ADDENDUM NO. 1

TO: ALL BIDDERS  
PROJECT: ITB PW 46-21 – VETERANS PARK  
BID TIME AND DATE: 03:00 PM local time on June 09, 2021 No Change

May 27, 2021

MARGARET  
CORBIN

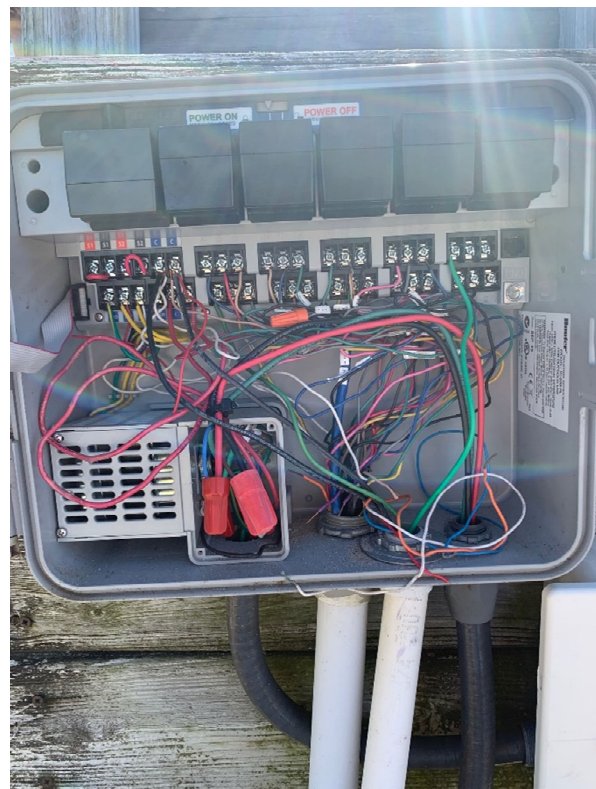
The statues that will be erected within Veterans Park are bronze depictions of female veterans – a total of eight statues. Each statue is slightly more than life-size – approximately 6 feet in height and weighs between 400 – 500 pounds. A rendering of one of the statues that is representative of the eight is shown on page 6 of 11.
